SUBJECT: Forwards response to NRC 820510 hypothetical questions re  
 postulated loss of essential spray pond spray nozzles due to  
 tornado missiles.Util relies on probabilistic risk  
 assessment as response to SER Section 9.2.5.

REQUEST FOR ADDITIONAL INFORMATION  
TORNADO MISSILE PROTECTION FOR THE  
ULTIMATE HEAT SINK

PALO VERDE NUCLEAR GENERATING STATION, UNITS 1, 2 AND 3

Figure 1

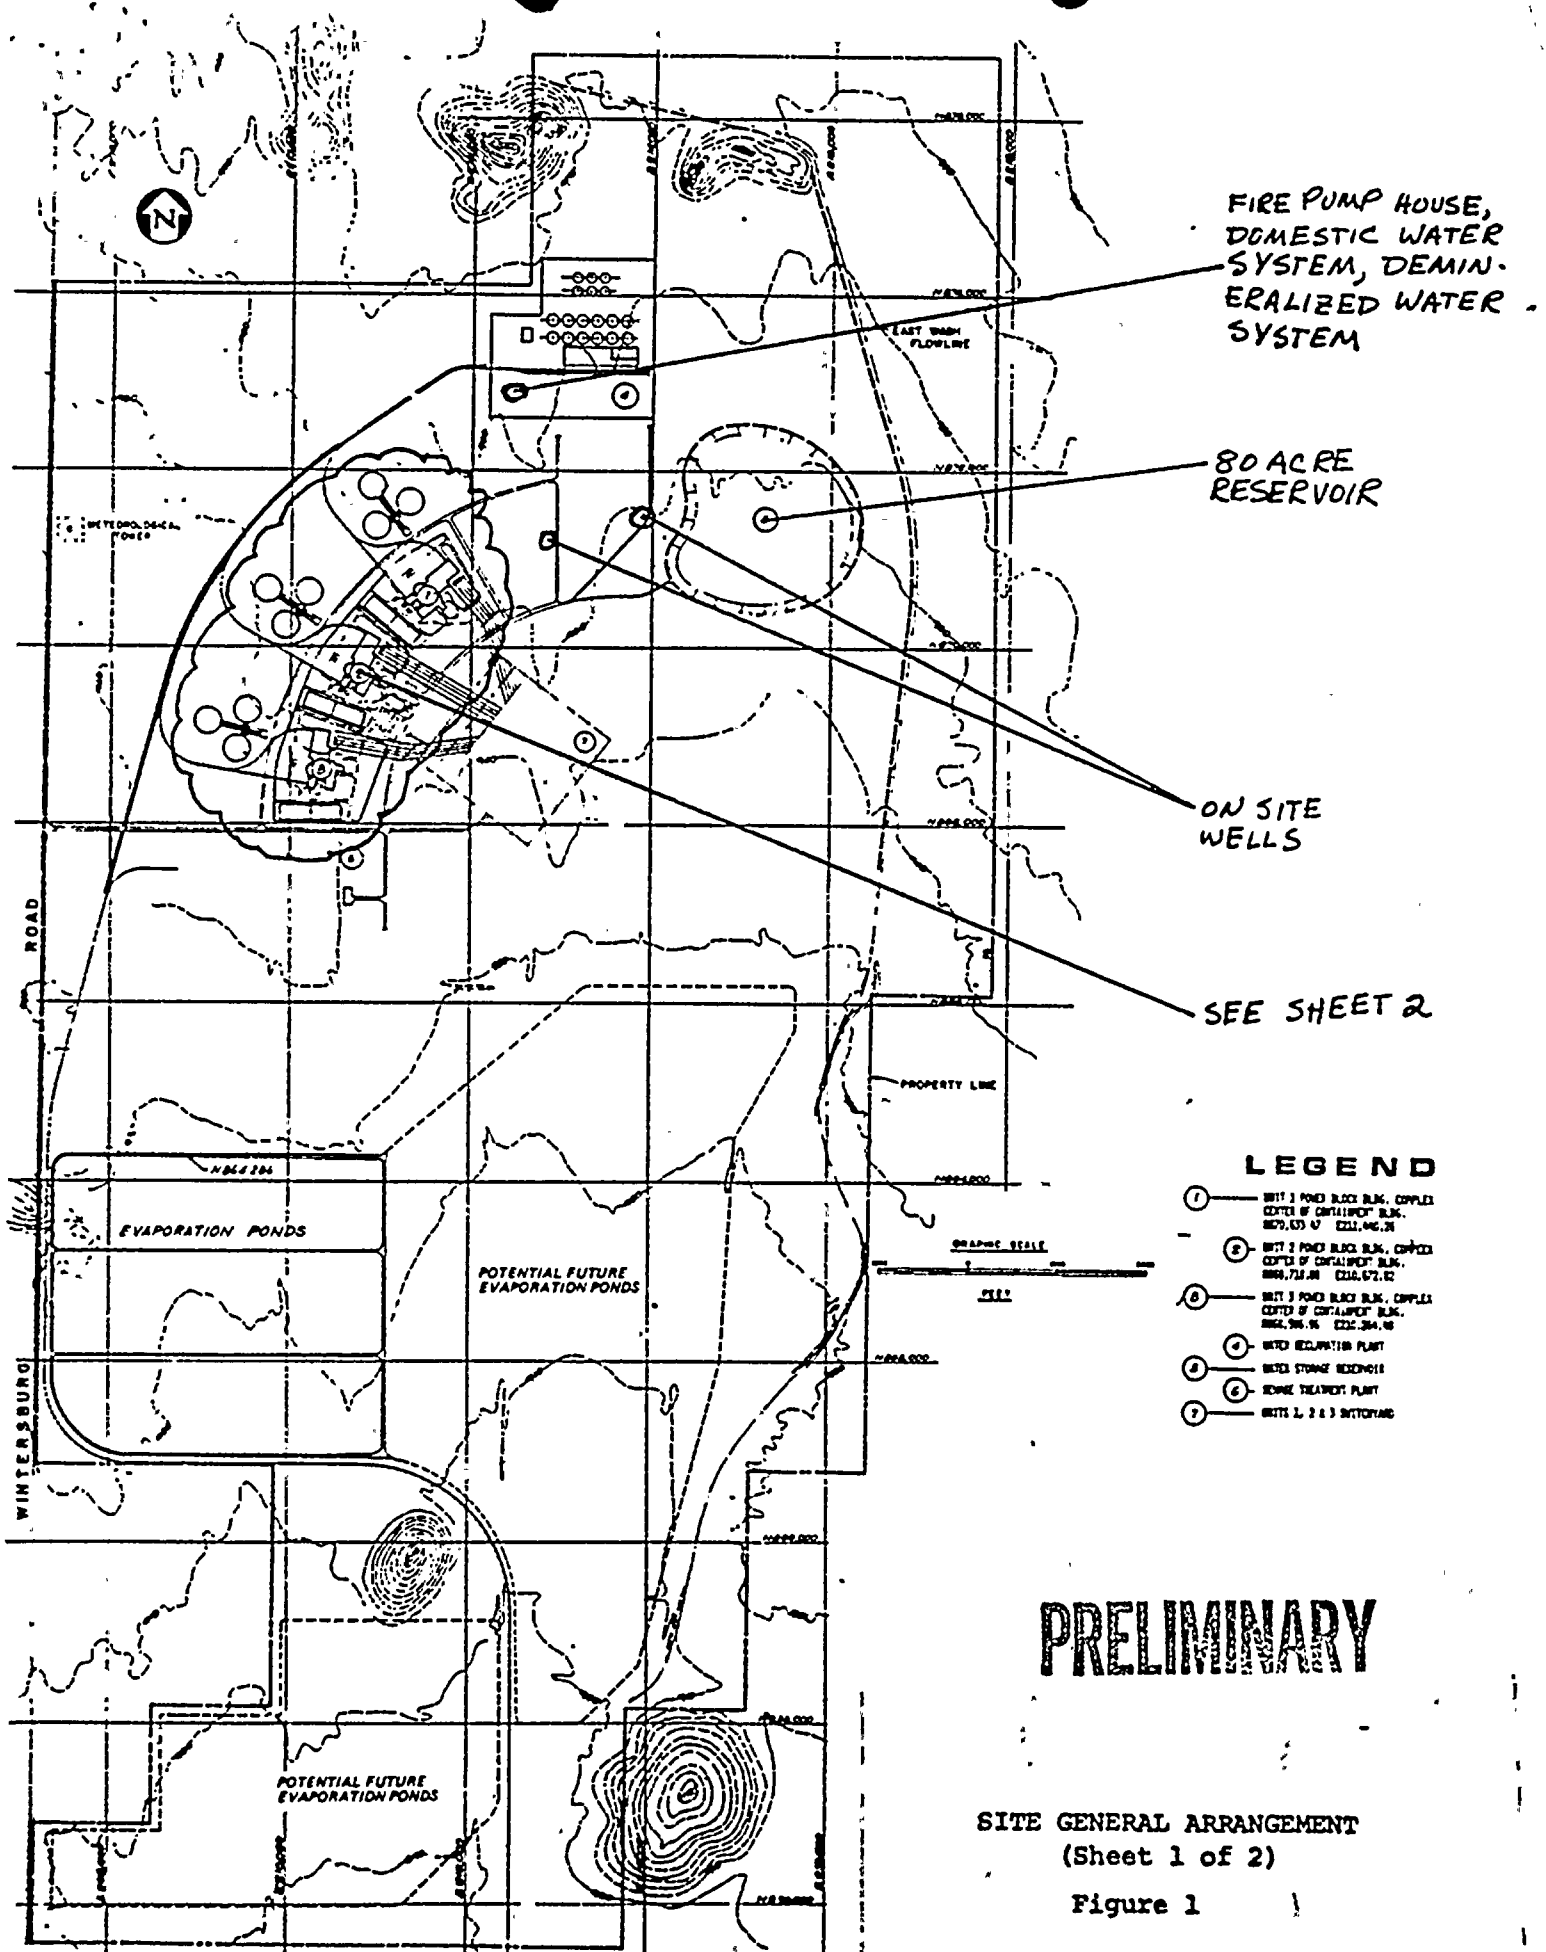
- a. Other than the condensate storage tank, none of the sources identified appears to be tornado missile protected. Justify the availability of the alternative AFW sources (either by separation or inherent protection by location in suitable structures).

The analysis of extended sources of auxiliary feedwater has considered the potential for tornado missile damage of these sources. It was concluded that due to spatial separation, intervening barriers, and inherent design resistance to missiles, it was not credible to postulate loss of all alternate feedwater source capability.

Figure 1 depicts the site and the locations of alternate feedwater sources. As can be seen, the sources are spread out over about 1½ square miles. Thus, due to spatial separation alone it is unlikely that tornado damage would occur at all locations during the course of the postulated scenario.

The spray ponds and reactor makeup water tanks are isolated from the onsite wells and domestic/demineralized water systems by the concrete buildings of the power block. These buildings act as barriers providing additional assurance that tornado missiles will not disable both areas. CVCS and LRS components are located inside reinforced concrete structures.

Lastly, the circulating water system basins and the spray ponds are excavated structures. Even with substantial structural damage, a large quantity of impounded water would remain.

Thus, while none of the individual sources is fully missile protected, the system of sources is missile protected due to the separation of sources.
